**APPLICATION FOR  
URBAN DESIGN COMMISSION  
REVIEW AND APPROVAL**

6500 Normandy Lane  
91 Unit Condominium Building PUD (UDD – SIP) Submission

### Design Revision

Per your design review comments of April 25, 2007, we have incorporated the following revisions.

SITE PLAN

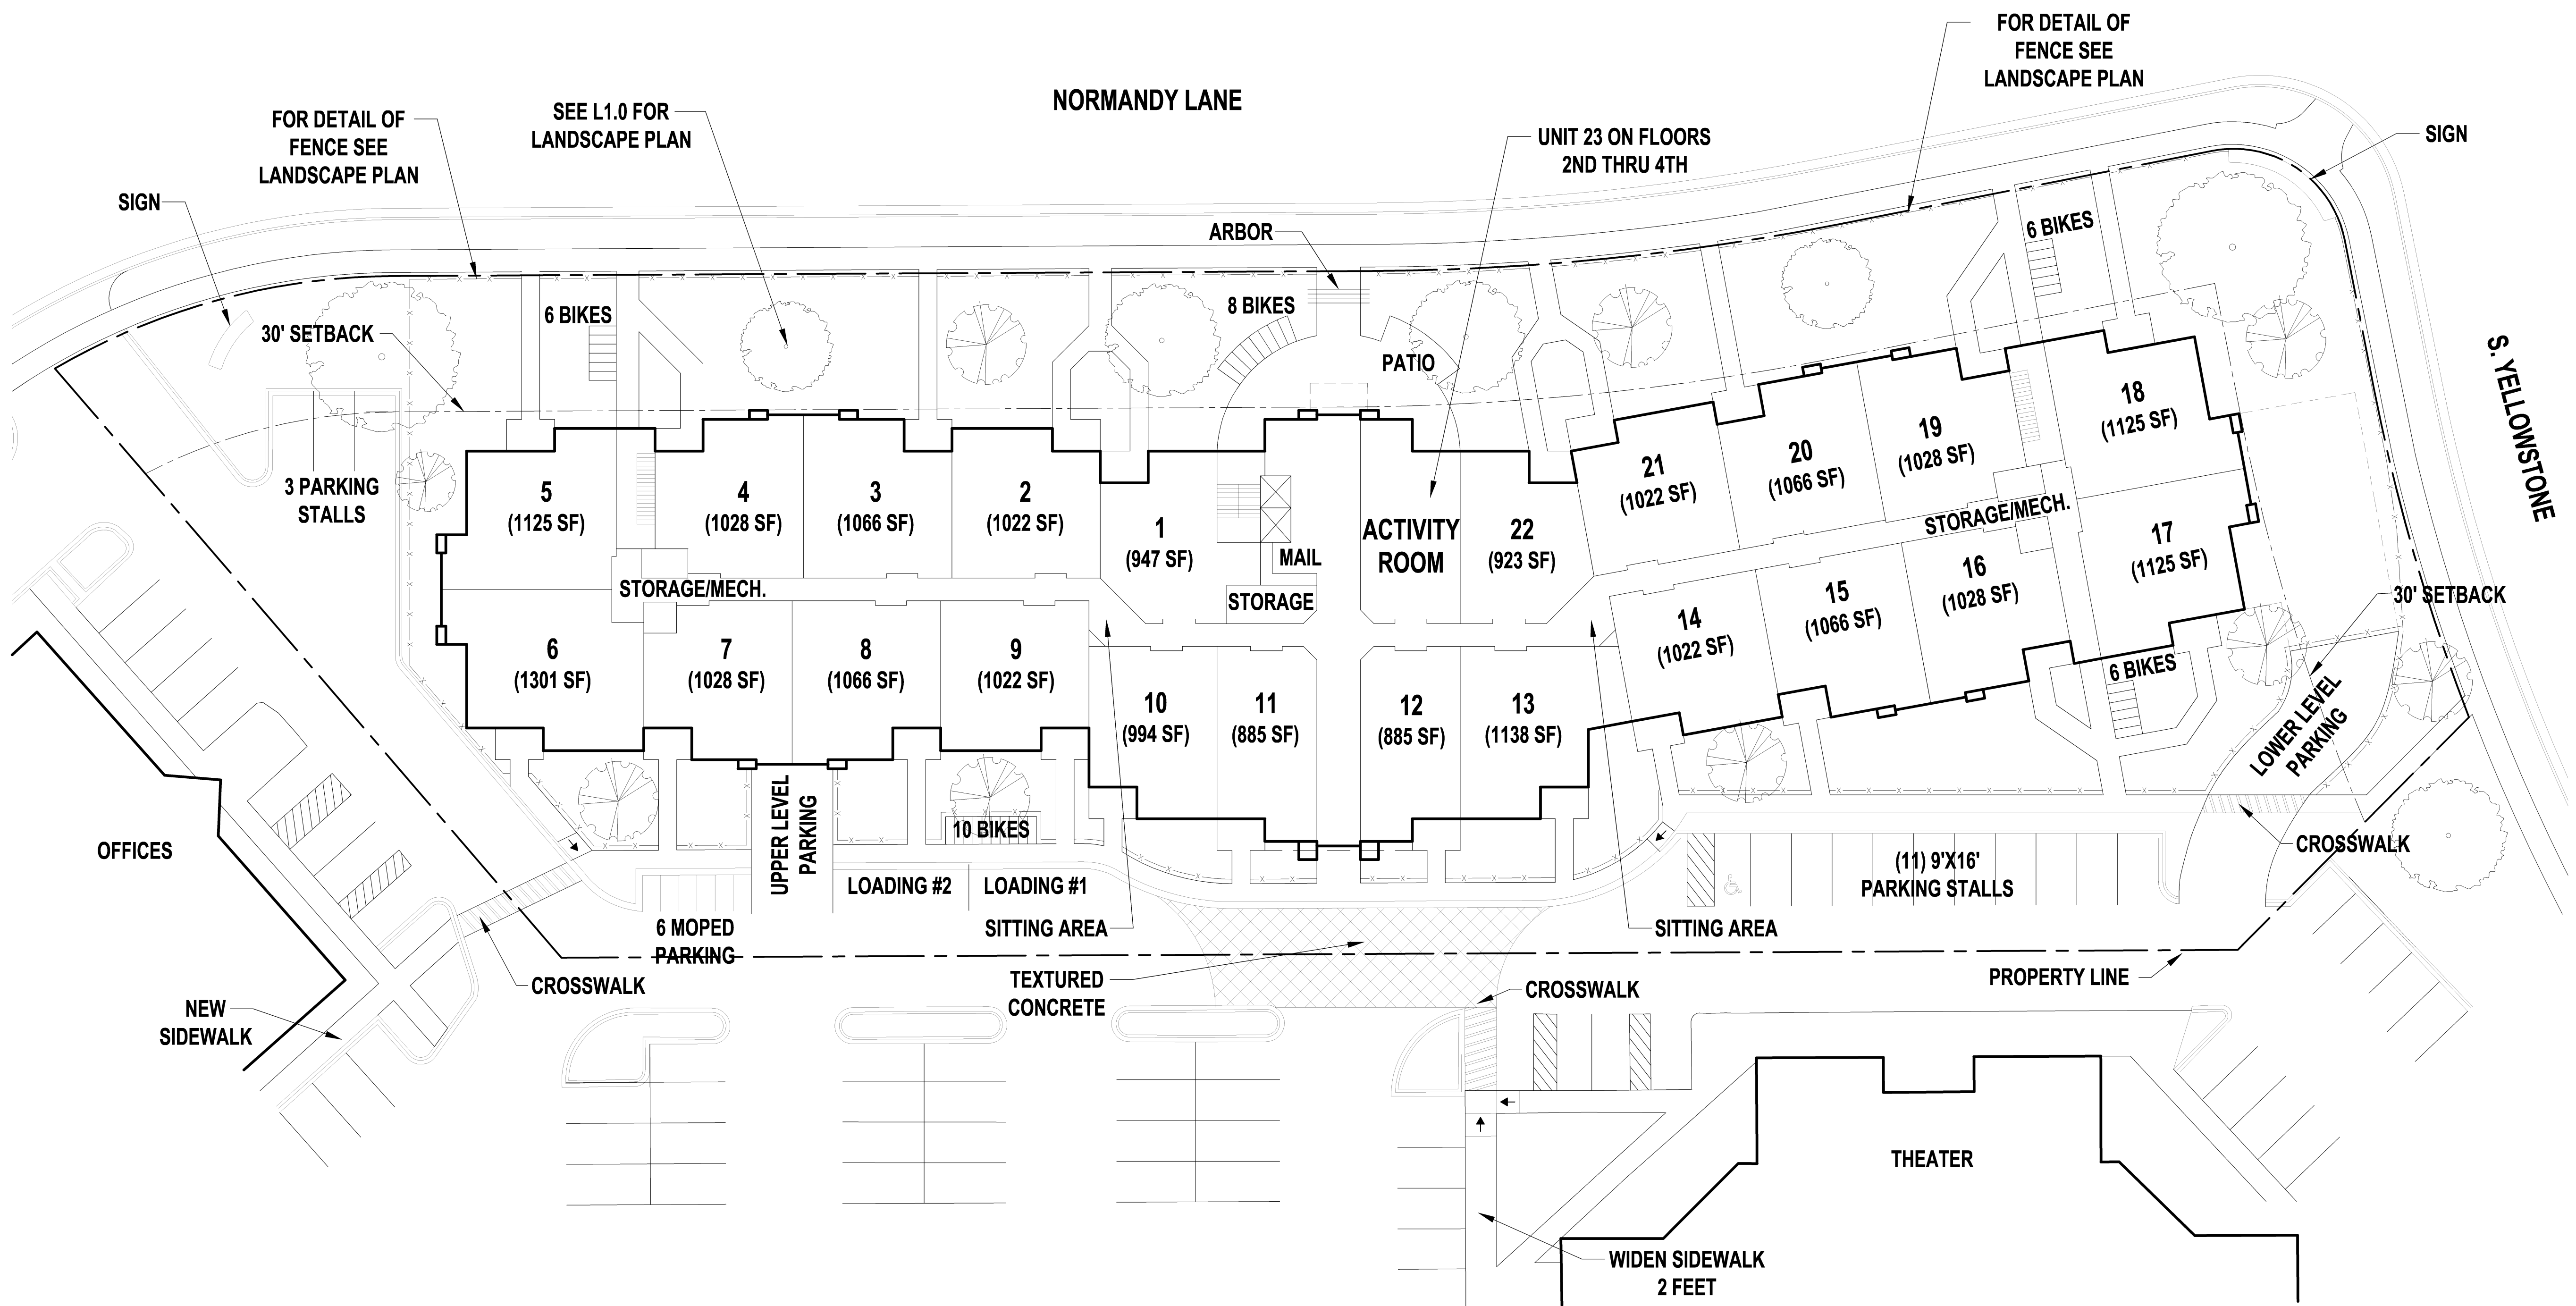
- The main entrance to the building was relocated to front off of Normandy Lane. The activity room and patio activity areas were relocated to the Normandy Lane side.

- Pedestrian connection walks to Market Square and the streets were added.
- The rear sidewalk was straightened out to be a more direct route.
- Bicycle racks have been scattered around to the different sides and entrances.

- Moped parking has been added.
- The covered drive to the lower level has been covered with green area up to the point that the drive requires clearance. This eliminates the high side walls along the drive.

- A fence has been added next to the sidewalk to create a personal front door area for the ground floor residences.
- Screening has been added to the rear of the adjacent retail delivery area.

### SITE LIGHTING PHOTOMETRIC PLAN

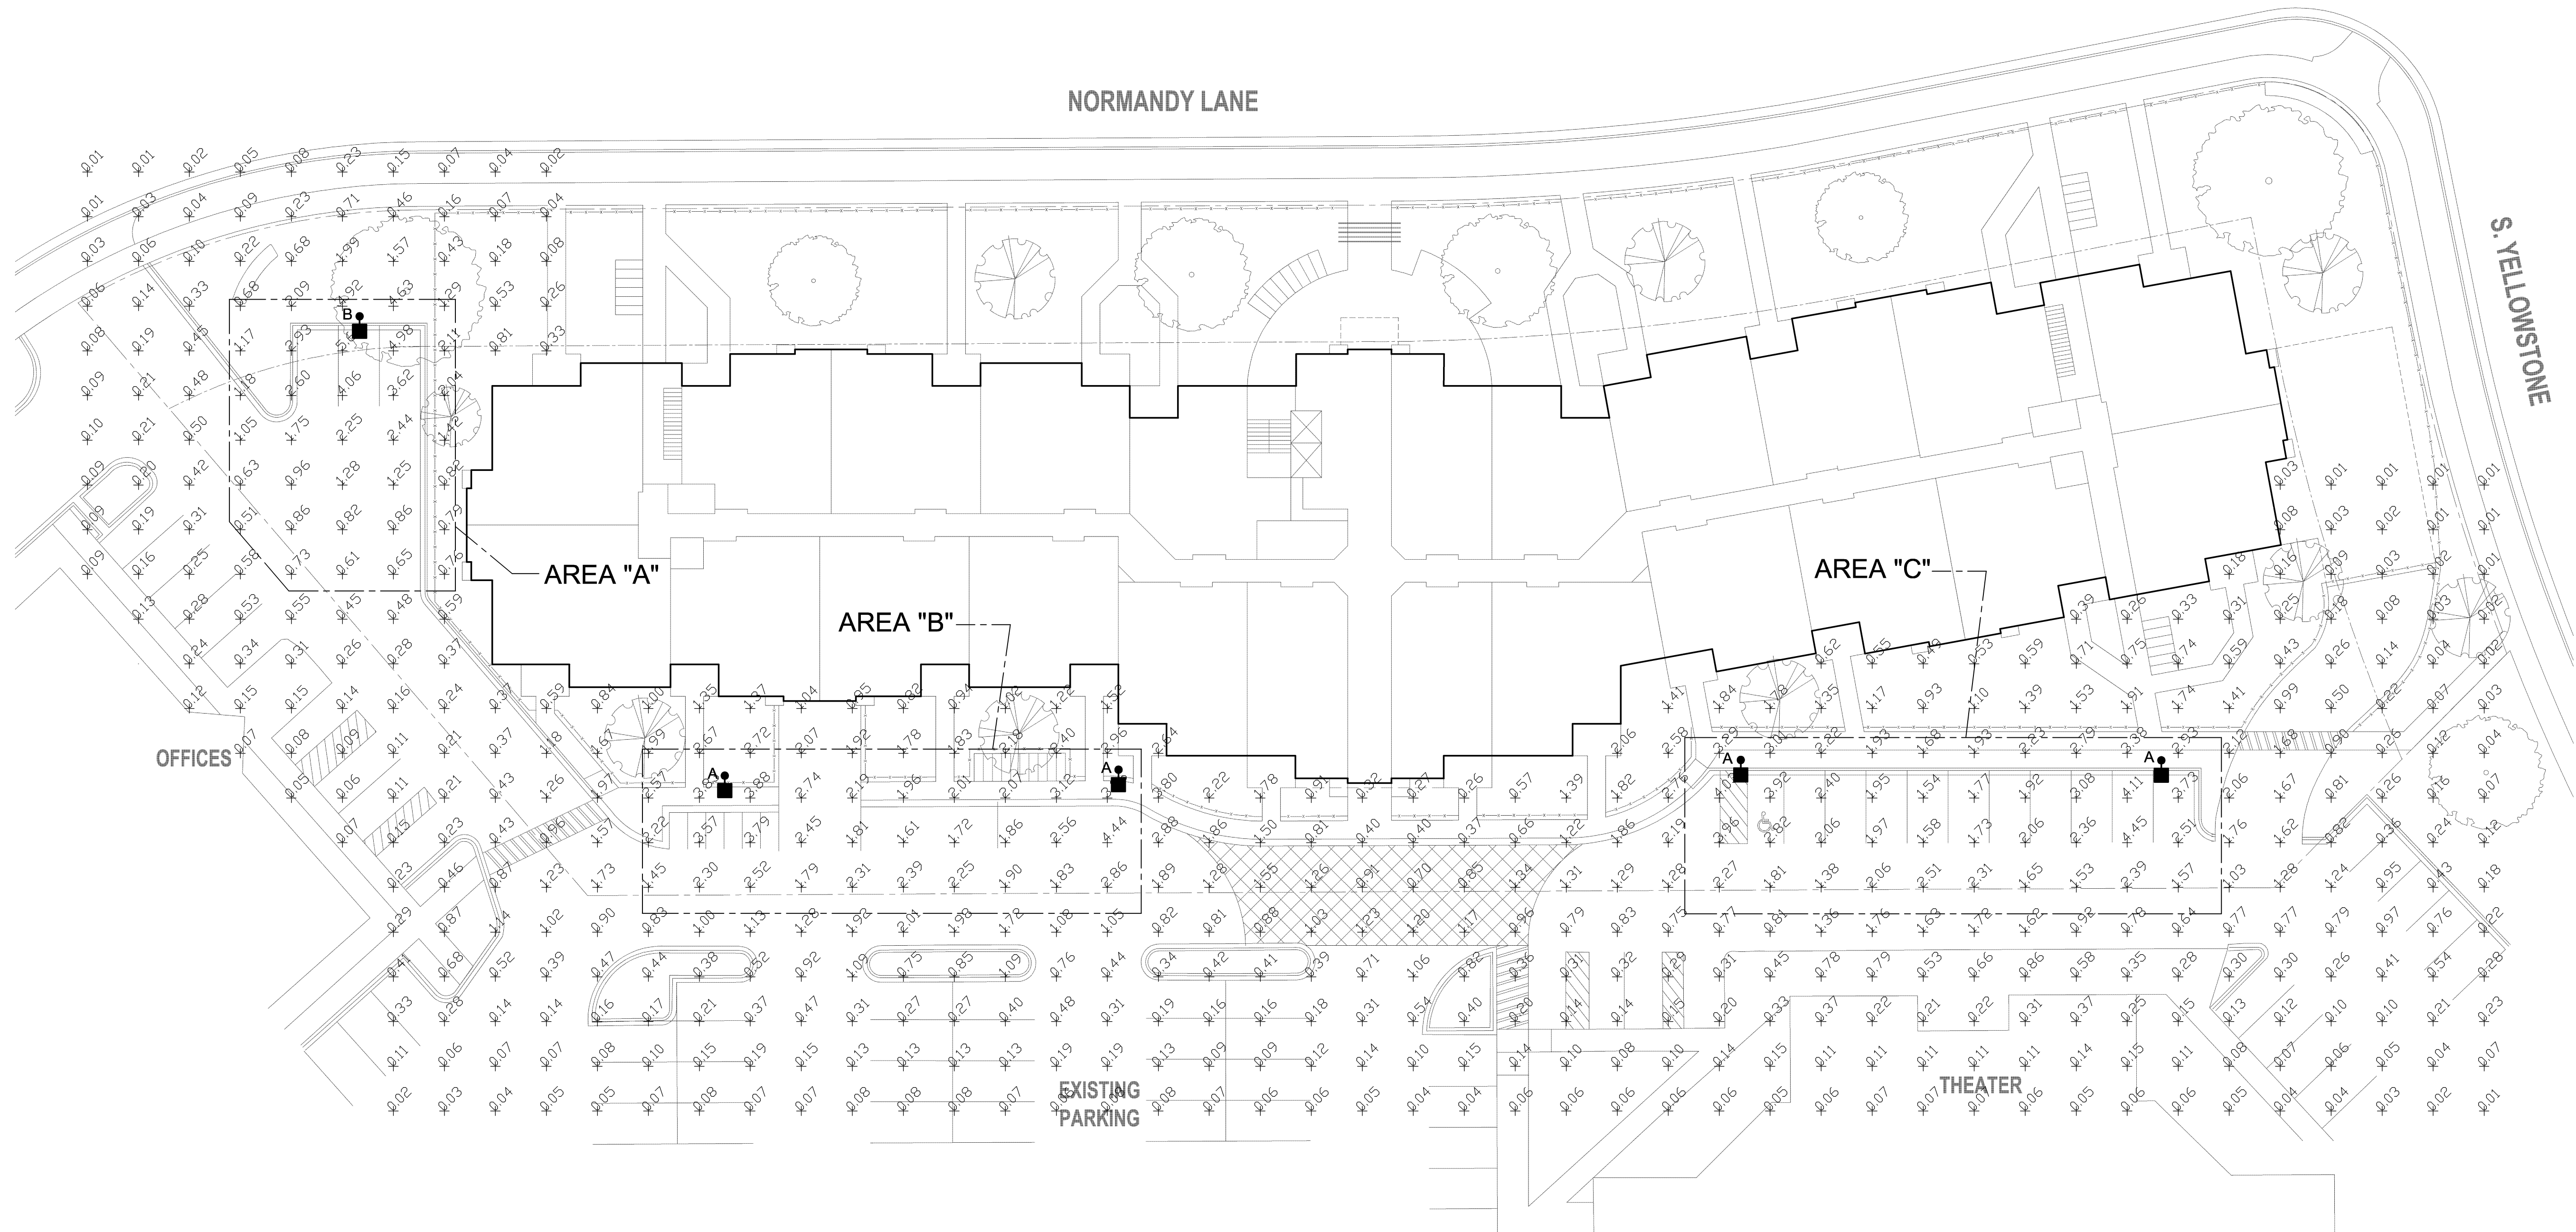
- Site lighting has been switched to metal halide.
- Landscape plan was revised to create edges at the building.
